DRAFT FINAL

**SEAD-25 and SEAD-26
PROJECT SCOPING PLAN FOR PERFORMING A
CERCLA REMEDIAL INVESTIGATION /
FEASIBILITY STUDY (RI / FS) AT THE FIRE
TRAINING AND DEMONSTRATION PAD (SEAD-25)
AND FIRE TRAINING PIT AND AREA (SEAD-26)**

REVISED DRAFT SEAD-25 AND SEAD-26
PROJECT SCOPING PLAN FOR PERFORMING
A CERCLA REMEDIAL INVESTIGATION/FEASIBILITY STUDY (RI/FS)
AT THE FIRE TRAINING AND DEMONSTRATION PAD (SEAD-25)
AND FIRE TRAINING PIT AND AREA (SEAD-26)

**PROJECT SCOPING PLAN
REMEDIAL INVESTIGATION/FEASIBILITY STUDY
AT SEAD-25 and SEAD-26
SENECA ARMY DEPOT ACTIVITY
ROMULUS, NEW YORK**

FIGURE 3-4
EXPOSURE PATHWAY SUMMARY

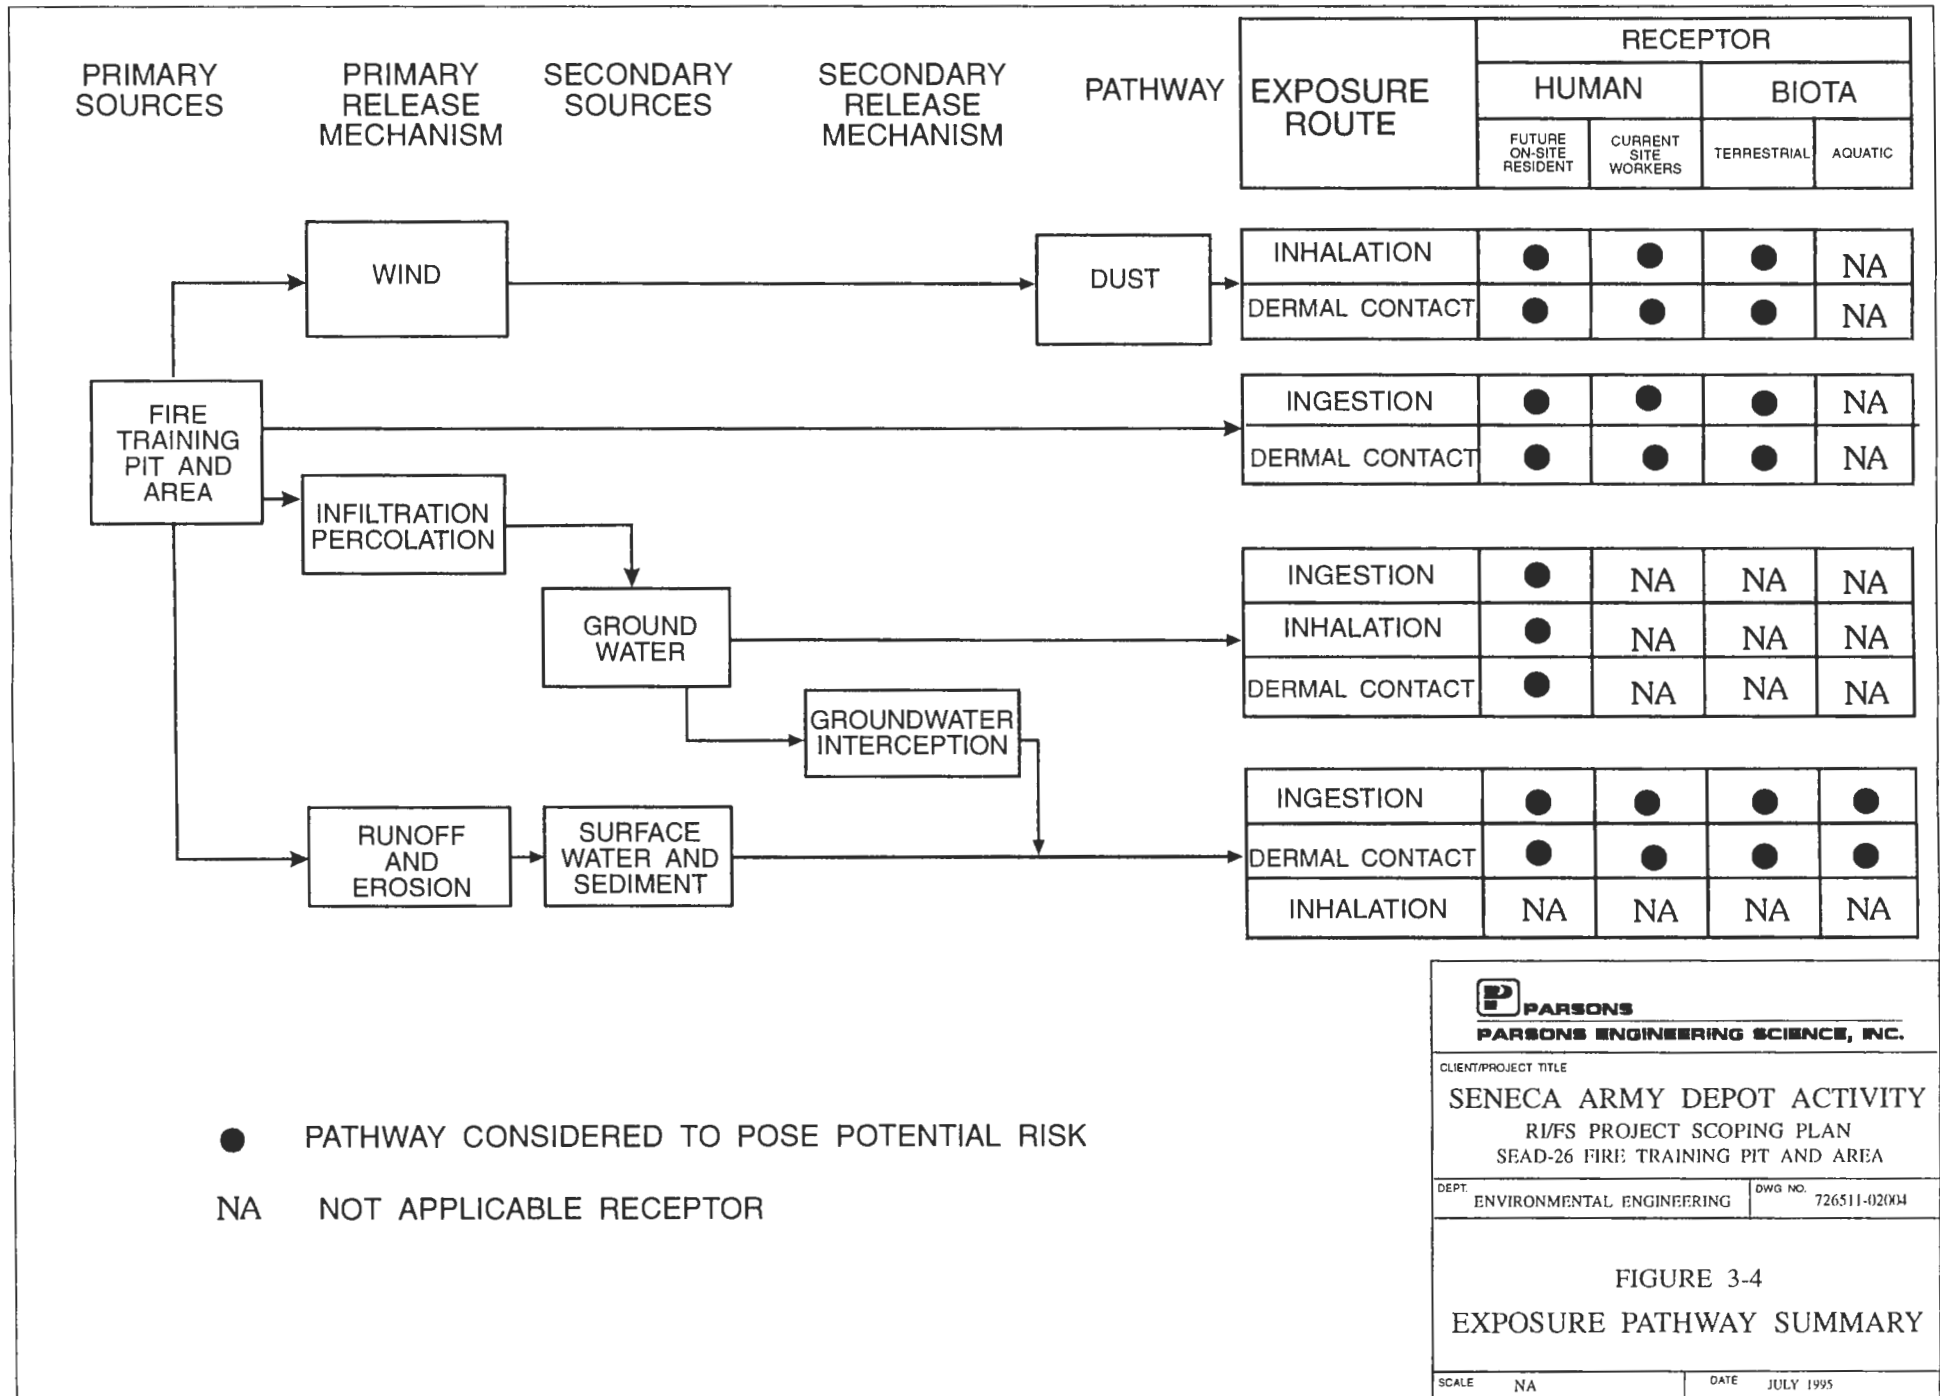
**Comment #7**                    **Figure 3-4:** A section of the matrix shown on this figure has been left blank, i.e., the inhalation pathway for groundwater under aquatic biota, the appropriate symbol should be placed within this box.

**Response #4**                    Agreed. This comment applies to Figures 3-3 and 3-4 and Sections 3.2.2.1 and 3.2.4.1 in the Project Scoping Plan for SEADs-25 and -26. The figures and text in the two sections have been changed to indicate aquatic biota could be a receptor for ingestion of and dermal contact with surface water and sediment.

**Response #5**                    Agreed. This comment applies to Figures 3-3 and 3-4 and Sections 3.2.2.2 and 3.2.4.2 in the Project Scoping Plan for SEADs-25 and -26. Incidental ingestion of soil has been added as a potential exposure route for current site workers and visitors.

**Response #7**                    Agreed. This comment applies to Figures 3-3 and 3-4 and Sections 3.2.2.1 and 3.2.4.1 in the Project Scoping Plan for SEADs-25 and -26. Inhalation of volatiles from surface water has been added to SEAD-25. Inhalation of volatiles from surface water at SEAD-26 has not been added because volatiles are not potential chemicals of concern based on the ESI data.

- Response #8**                    Agreed. This comment applies to Figures 3-3 and 3-4 and Sections 3.2.2.1 and 3.2.4.1 of the Project Scoping Plan for SEADs-25 and -26. Incidental ingestion of surface water has been changed to be considered to pose a potential risk to all four receptors.

- Response #11**                    Disagree. This comment applies to Figures 3-3 and 3-4 and Sections 3.2.2.4 and 3.2.4.4. Dermal contact could become more significant if dust is generated while walking across the site, a vehicle drives across the site, or the site is developed. Ingestion of particulates will not be included in the risk assessment for these two sites.

**FIGURE 4-2  
 LOCATION OF PROPOSED SURFACE  
 WATER AND SEDIMENT SAMPLES**

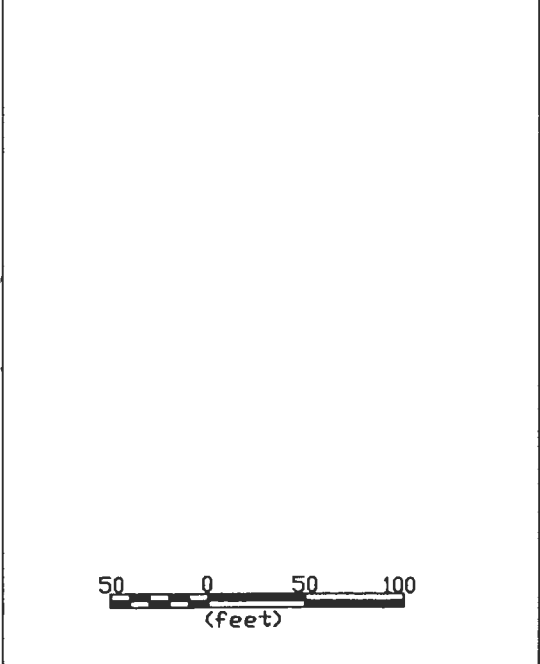
- i. SEAD-25, Figure 4-2, should indicate the direction of surface water flow, and clearly show the location of the two proposed sampling points in the upper reaches of Kendaia Creek.

- i. Agreed. Arrows have been added to show the direction of flow in the drainage channels and streams in Figures 4-2 and 4-4. Ground surface elevations are associated with the contours shown on the maps.

- i. Agreed. Arrows are used to show the surface water flow direction in Figure 4-2. The sampling locations SWSD25-9 and -10 are shown on Figure 4-2.
- ii. Agreed. The potential for groundwater to discharge to the ground surface or to the drainage channels and stream will be evaluated by examining the groundwater elevation data.

**FIGURE 4-4**  
**LOCATION OF EXISTING AND PROPOSED SURFACE WATER AND SEDIMENT SAMPLES**

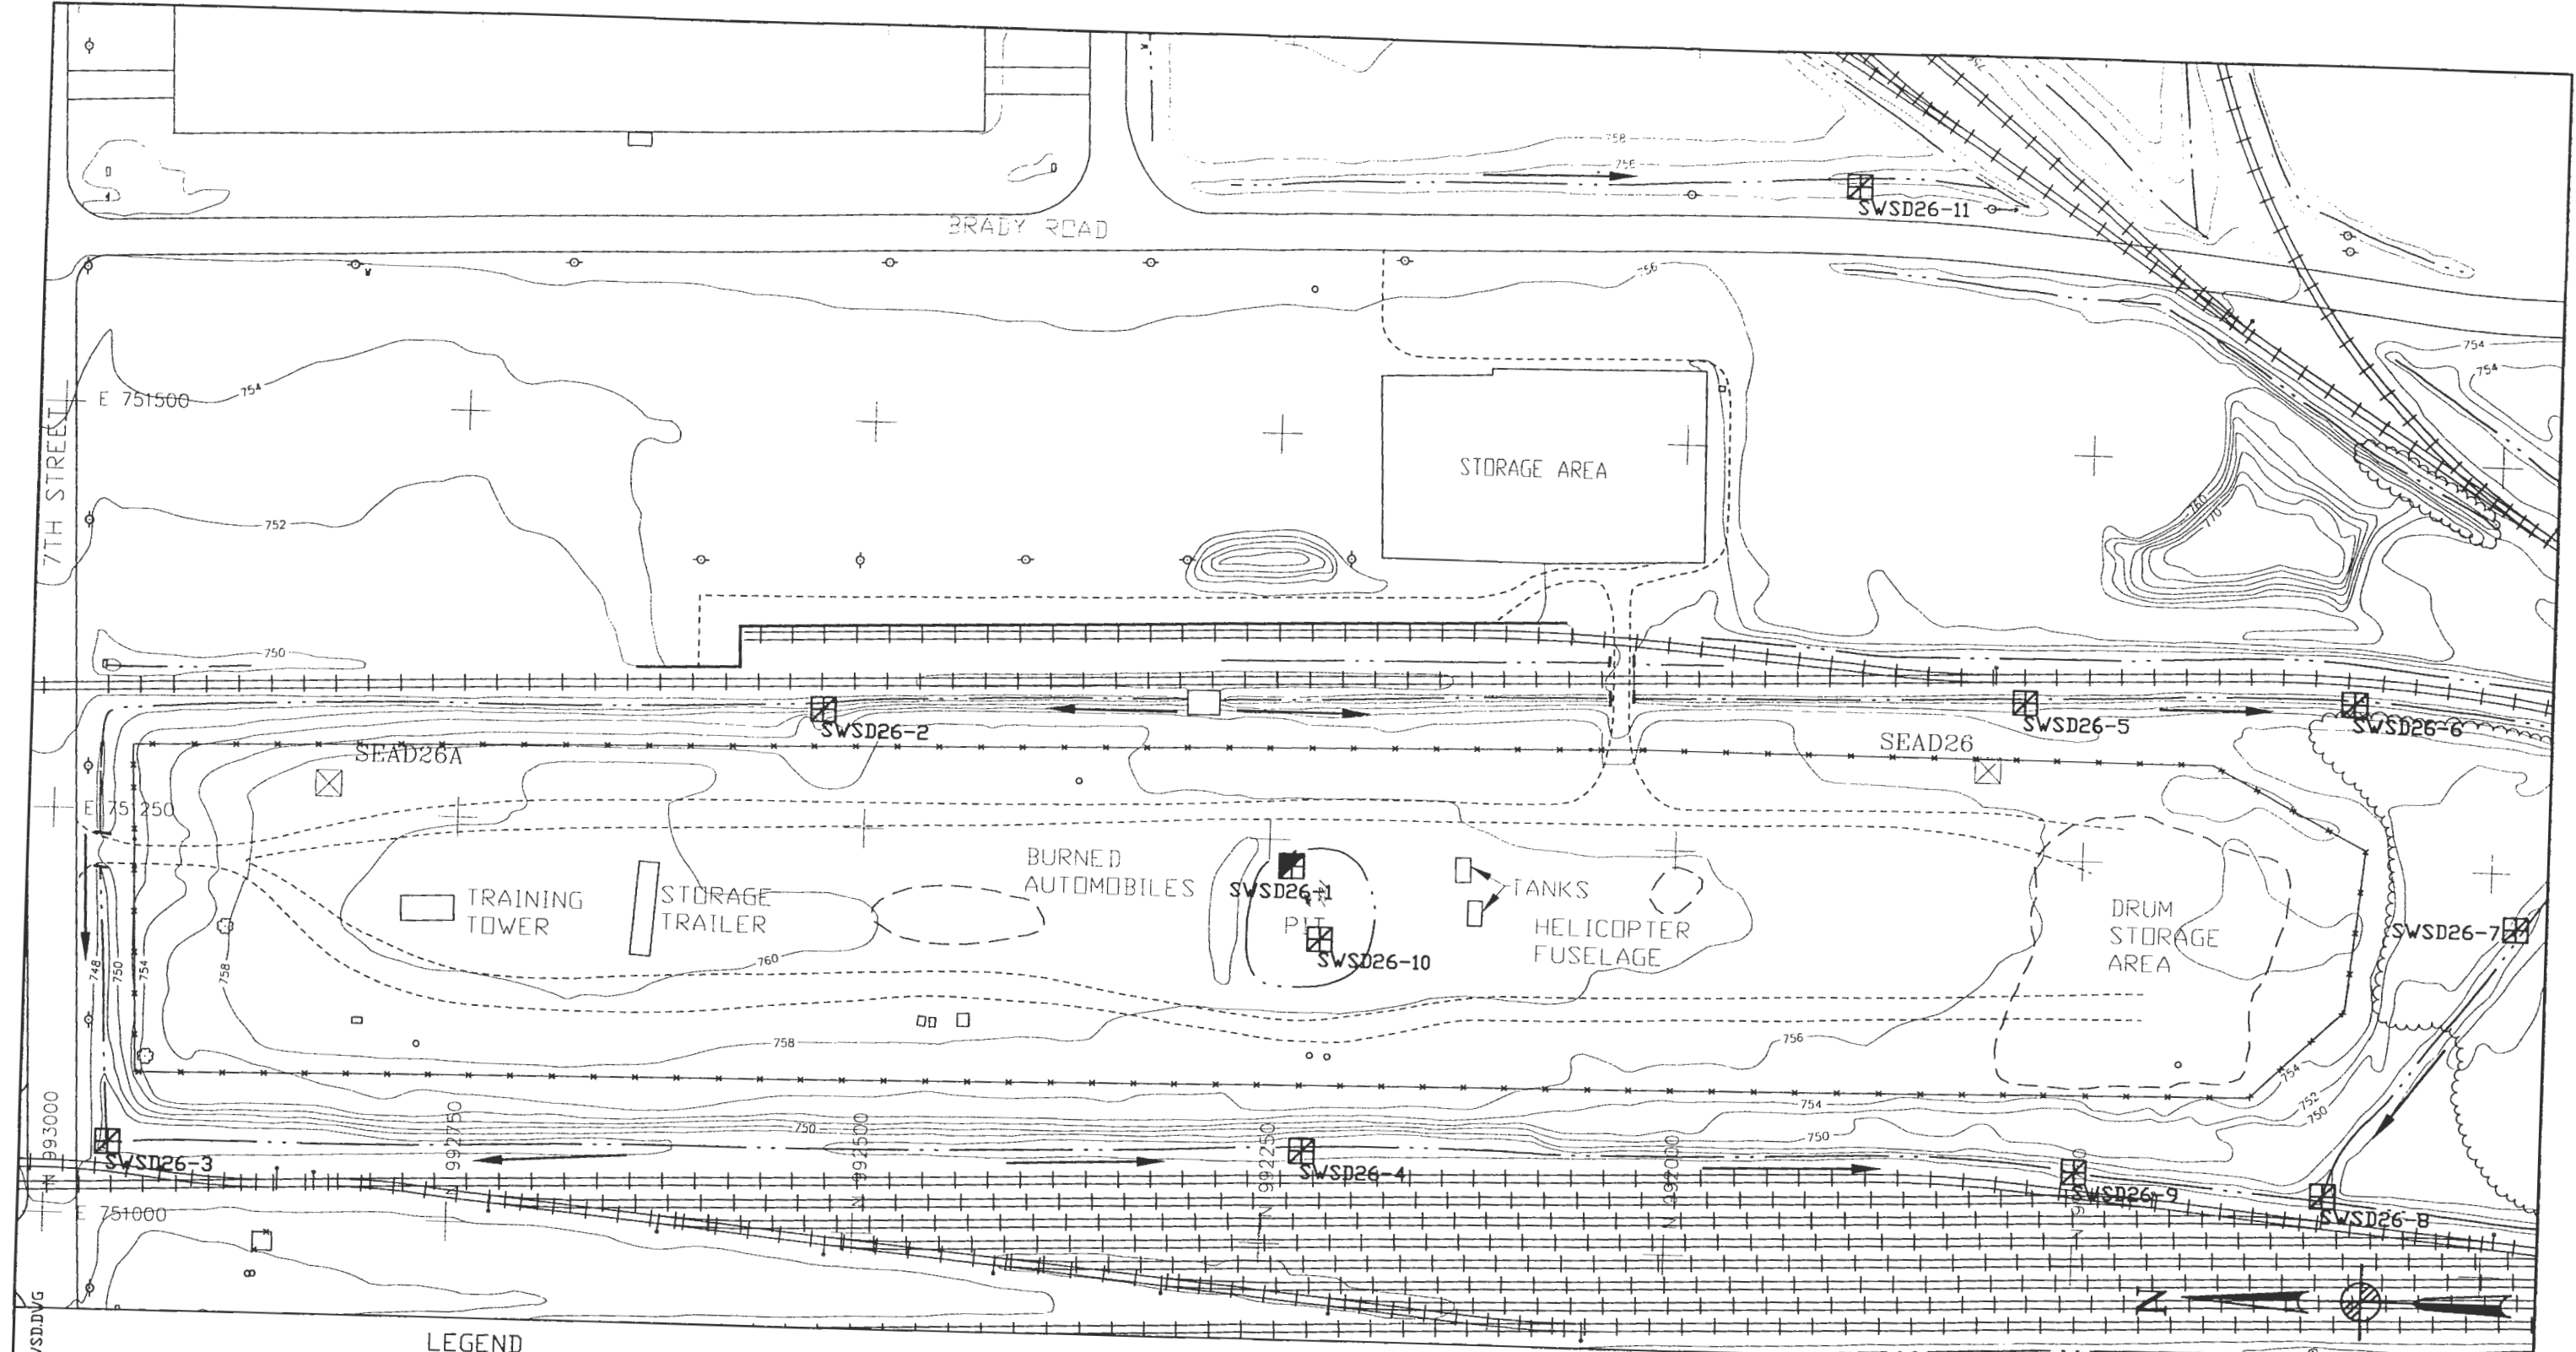
- i. SEAD-26, Figure 4-4, shows the location of proposed sediment and surface water sampling points around the fire pad. Due to the fact that the drum storage area is a potential source, additional sampling points should be established in this vicinity.
- ii. Mercury should also be added as a contaminant of concern for this site.
- iii. On page 2-25 there is a statement that "the results of these samples support the theory of multiple areas of elevated concentrations." This statement needs to be clarified.

- i. Four new surface water and sediment samples (SWSD26-6 to 9) have been added around the south end of the site in the vicinity of the drum storage area as shown on Figure 4-4.
- ii. Mercury and the other TAL metals will be analyzed in all the environmental samples.
- iii. This sentence was eliminated. This section on semivolatile organic compounds in soil at SEAD-25 (page 2-8 in the draft version) was rewritten to discuss surface soils separately from subsurface soils.
